Subject: **Permit Modification Request for the Section 404 Individual Permit, Section 401 Individual Water Quality Certification and CAMA Major Development Permit** for the proposed improvements to US 70 from existing four lanes at Radio Island to north of Olga Road (SR 1426), Carteret County, State Project No. 8.1162501, Federal Aid Project STPNHF-70(43), TIP R-3307, Debit \$570 (NCDWR) and \$100 (NCDCM) from WBS 34528.1.1

**PERMIT REVISION  
OCT 2017**

N.C.D.O.T.  
DIVISION OF HIGHWAYS  
CARTERET COUNTY  
PROJECT: 34528.1.1 (R-3307)  
US 70 FROM EXISTING FOUR LANES  
AT RADIO ISLAND TO US 70 NORTH  
OF SR 1429 (OLGA ROAD)

PROJECT REFERENCE NO.	SHEET NO.
R-3307	20
RW SHEET NO.	
ROADWAY DESIGN ENGINEER	HYDRAULICS ENGINEER

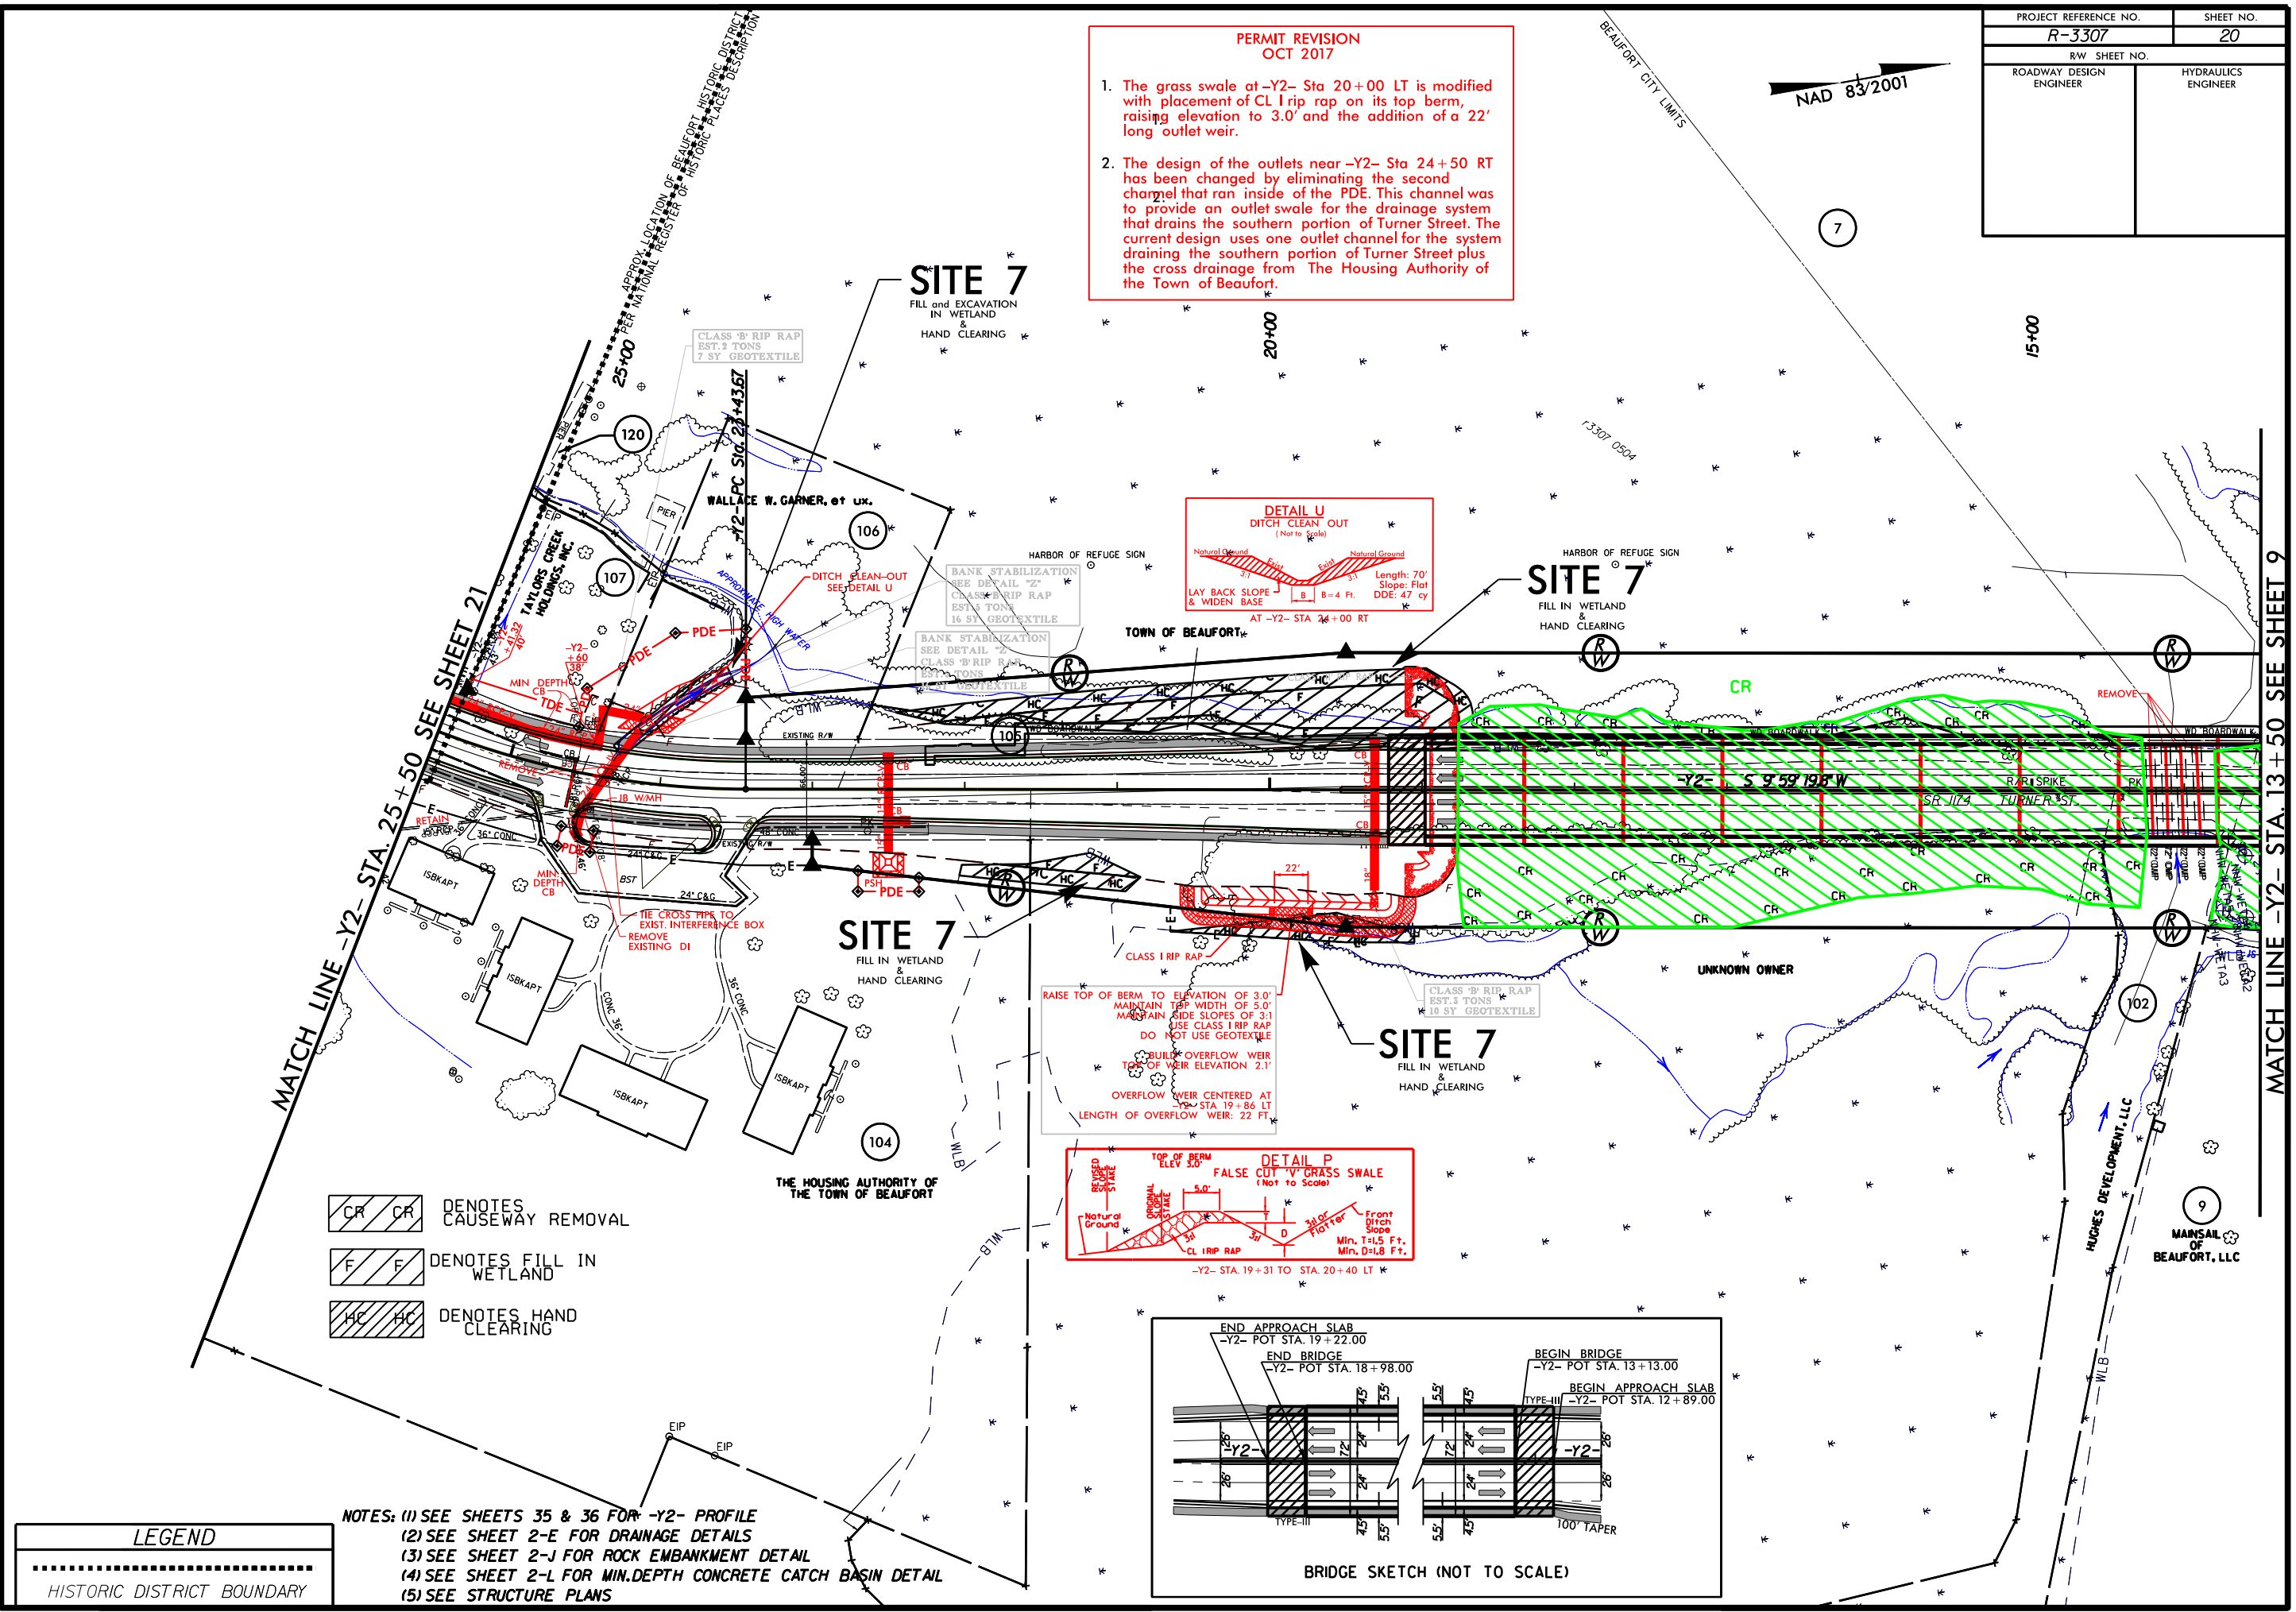
Due to erosion from wave action, the grass swale at Permit Site 7 (-Y2- Sta. 20+00 LT) is modified with placement of Class I riprap on its top berm, raising the elevation to 3.0 feet and the addition of a 22 foot outlet weir. Geotextile fabric will be placed along the outlet weir. This proposed change will result in an additional 0.03 acre of permanent impact to coastal wetland.

The design of the outlets near Permit Site 7 (-Y2- Sta 24+50 RT) has been changed by eliminating the second channel that ran inside of the PDE. This channel was to provide an outlet swale for the drainage system that drains the southern portion of Turner Street. The current design uses one outlet channel for the

- The grass swale at -Y2- Sta 20+00 LT is modified with placement of CL I rip rap on its top berm, raising elevation to 3.0' and the addition of a 22' long outlet weir.
- The design of the outlets near -Y2- Sta 24+50 RT has been changed by eliminating the second channel that ran inside of the PDE. This channel was to provide an outlet swale for the drainage system that drains the southern portion of Turner Street. The current design uses one outlet channel for the system draining the southern portion of Turner Street plus the cross drainage from The Housing Authority of the Town of Beaufort.

RAISE TOP OF BERM TO ELEVATION OF 3.0'  
MAINTAIN TOP WIDTH OF 5.0'  
MAINTAIN SIDE SLOPES OF 3:1  
USE CLASS I RIP RAP  
DO NOT USE GEOTEXTILE

BUILD OVERFLOW WEIR  
TOP OF WEIR ELEVATION 2.1'

OVERFLOW WEIR CENTERED AT  
-Y2- STA 19+86 LT  
LENGTH OF OVERFLOW WEIR: 22 FT

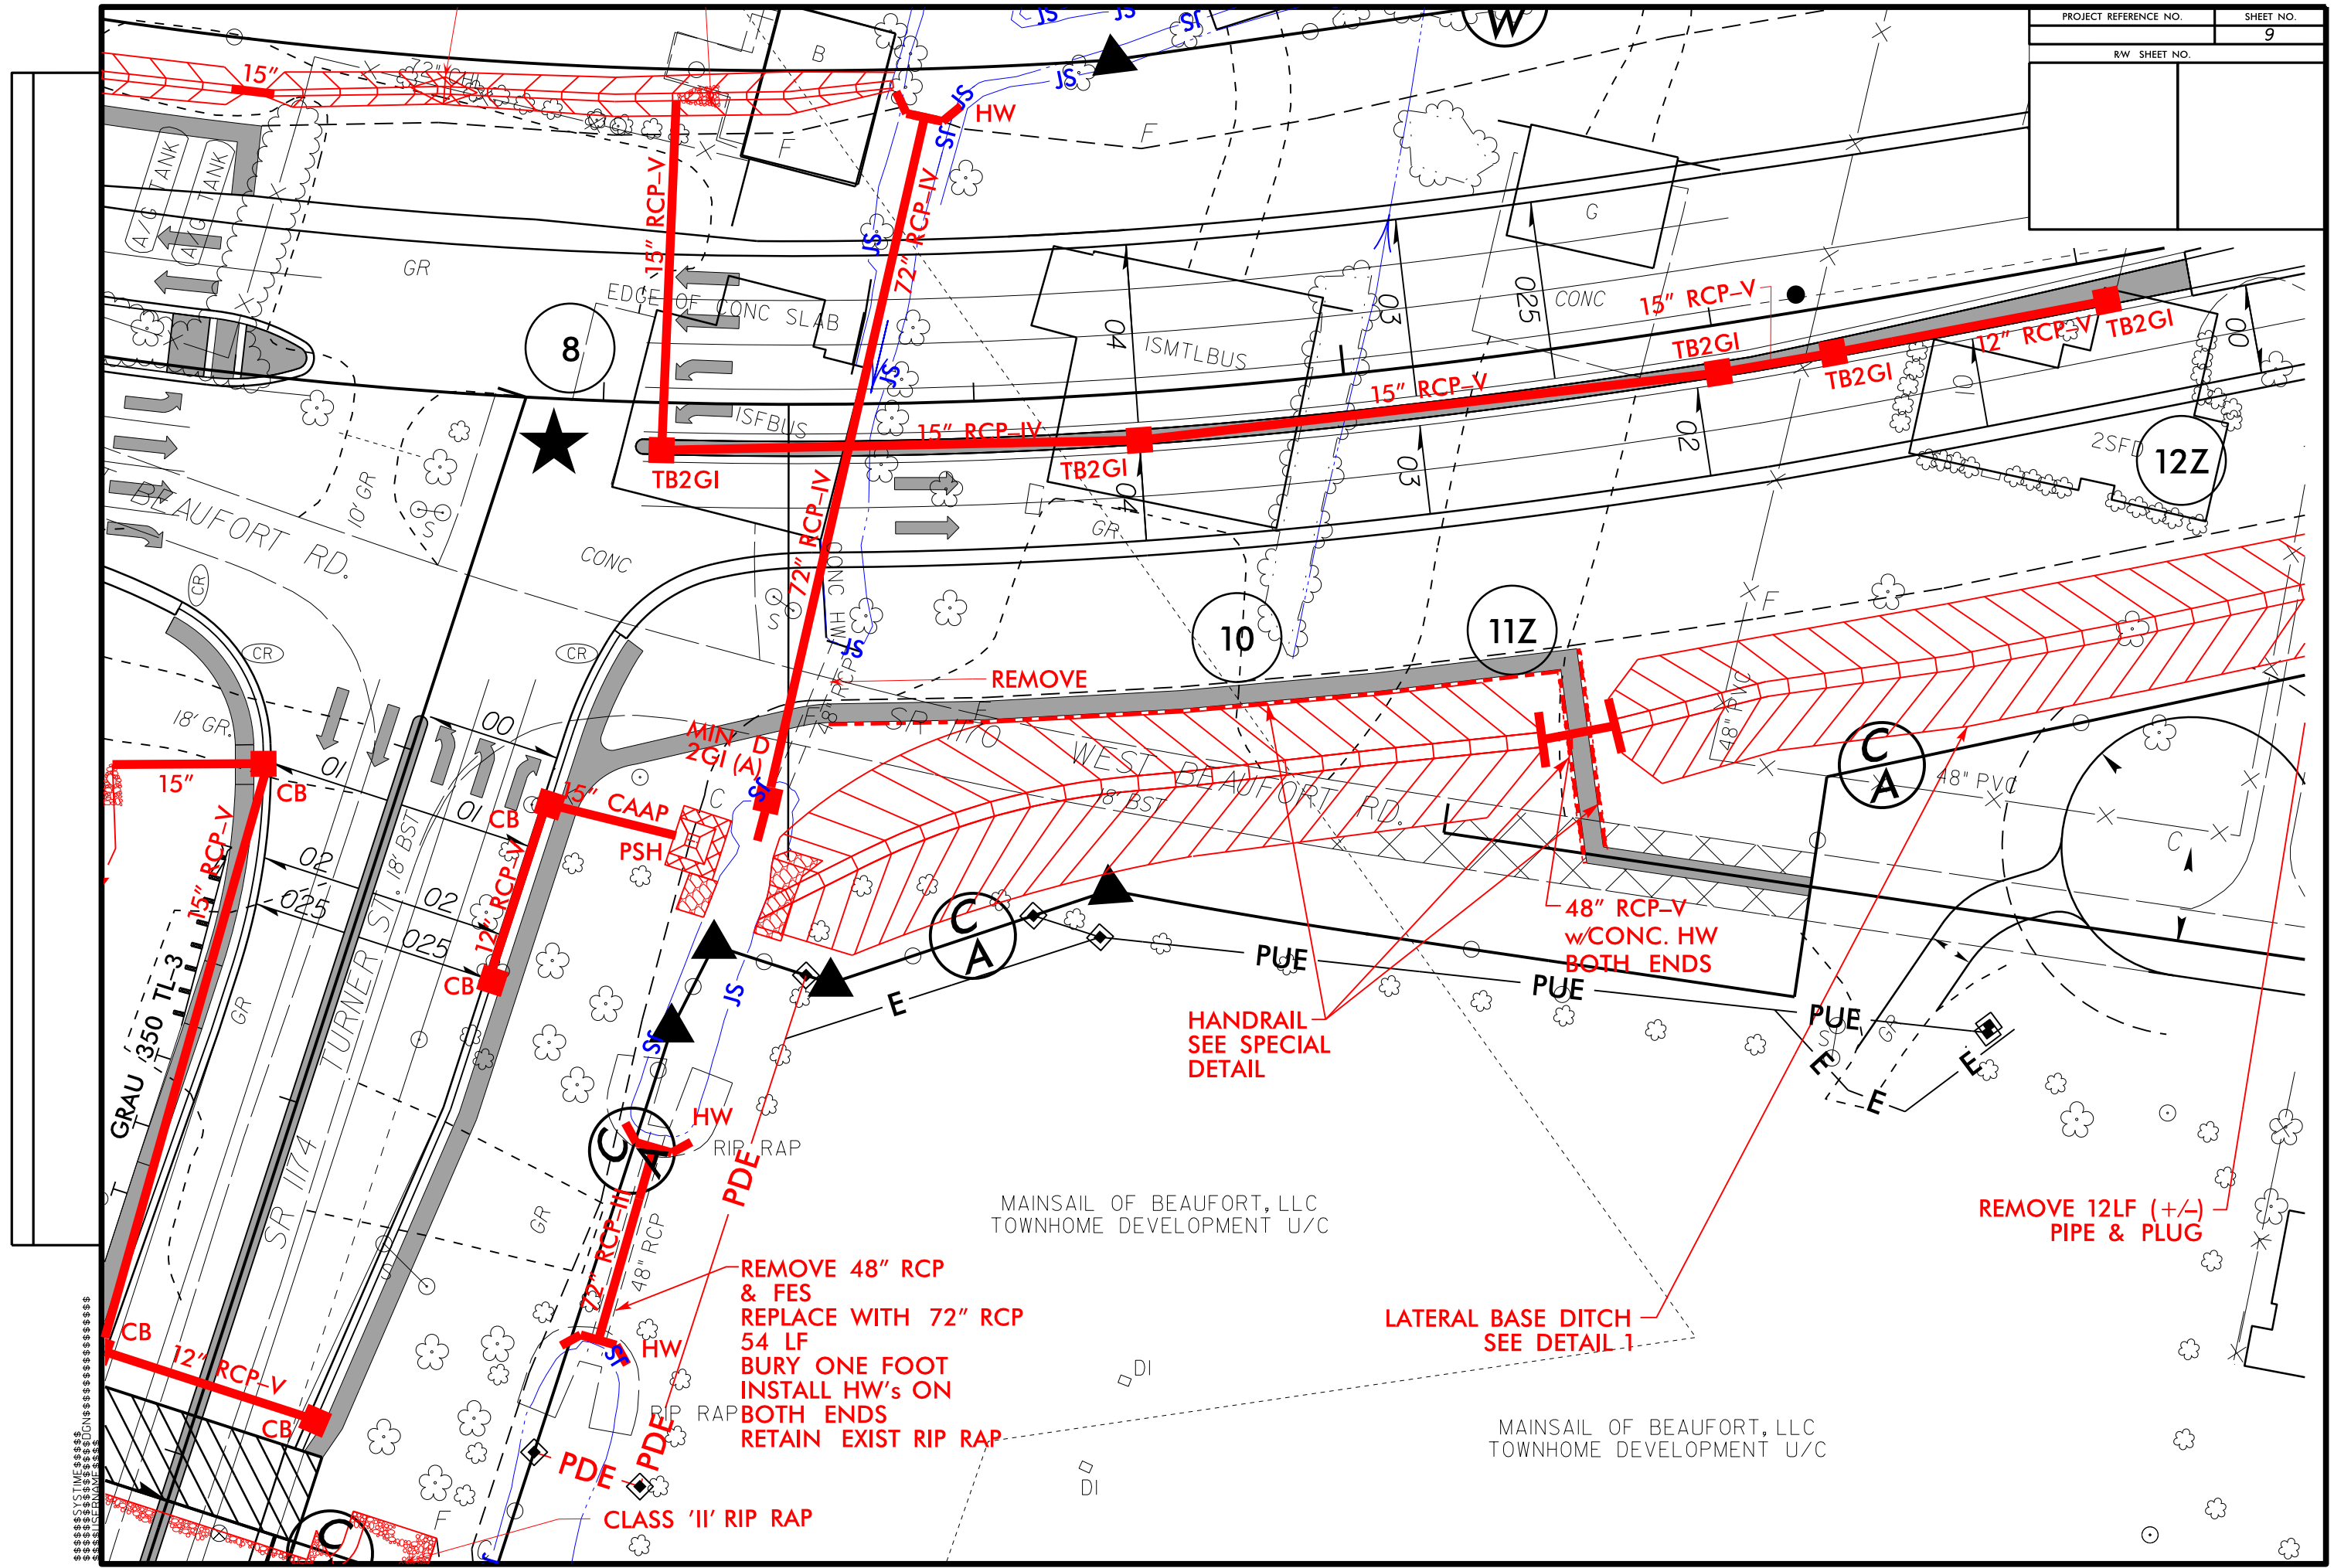
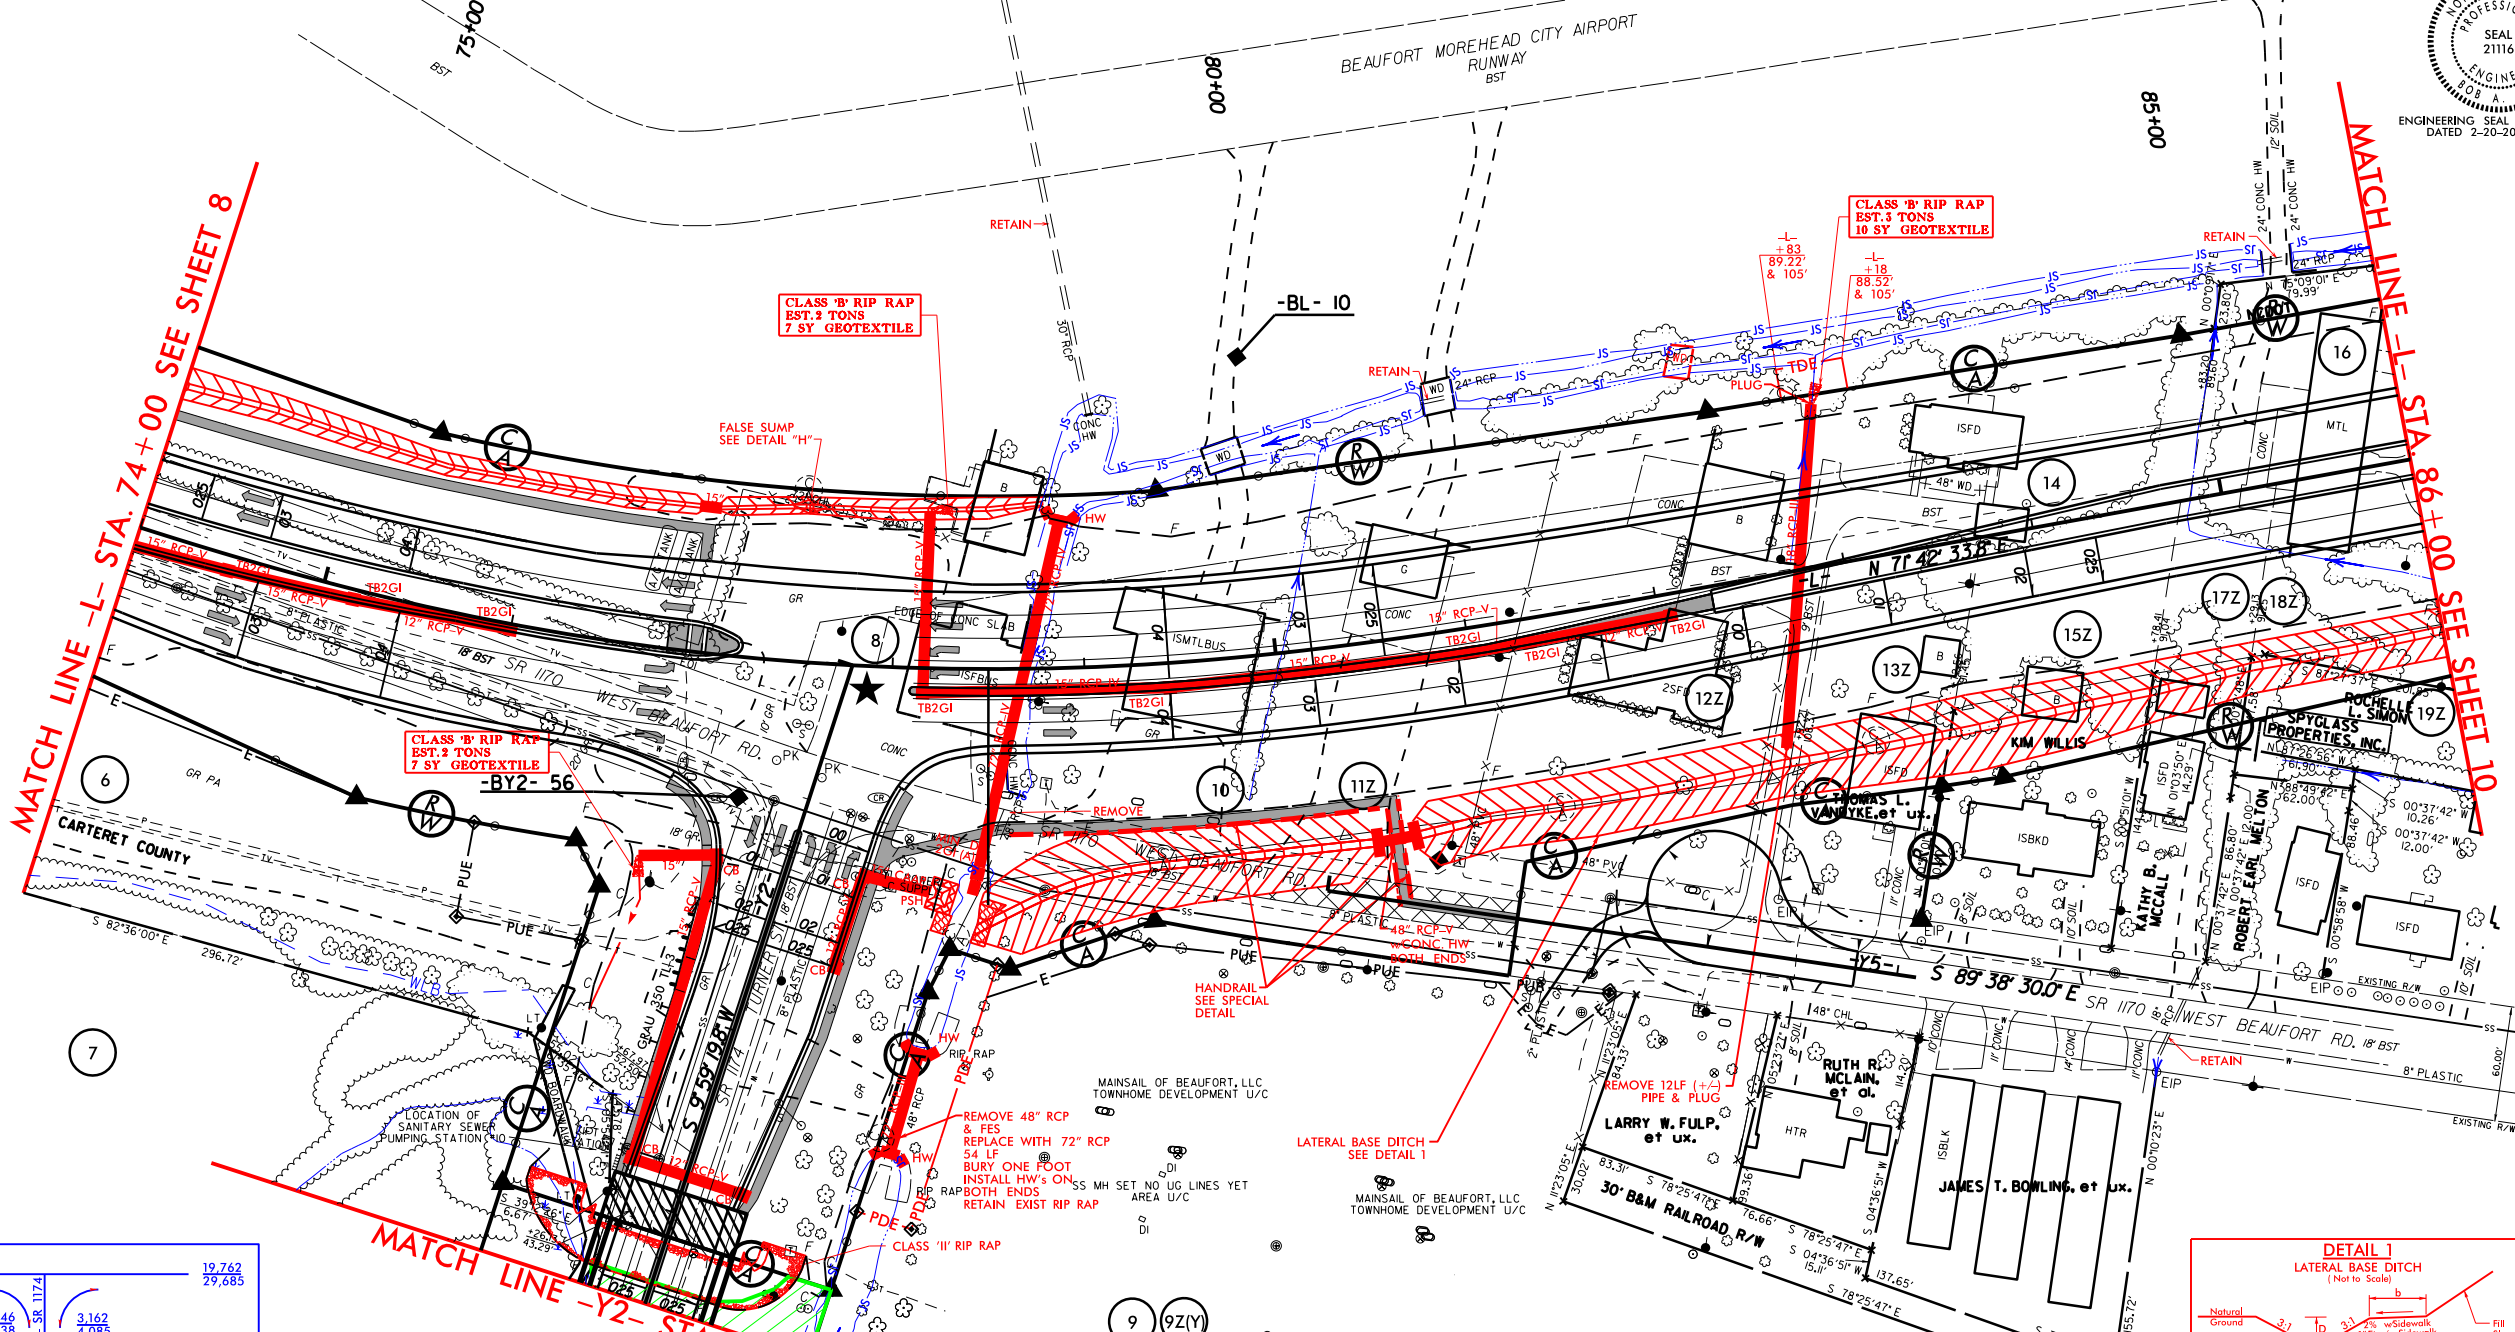
Also included are updated Plan Sheets 9 and Plan Sheet 9 Enlargement showing the confluence of the yet-to-be-excavated ditch with the existing jurisdictional stream, as requested for your records. It was deemed that no new impacts to jurisdictional resources was to occur at this site. One minor change not shown on the drawings is that the 48-inch pipe under the sidewalk will be increased to a 54-inch pipe to allow it to be buried one foot. This change will be reflected in the as-built plans for the project.

REMOVE 48" RCP  
& FES  
REPLACE WITH 72" RCP  
54 LF  
BURY ONE FOOT  
INSTALL HW'S ON  
BOTH ENDS  
RETAIN EXIST RIP RAP
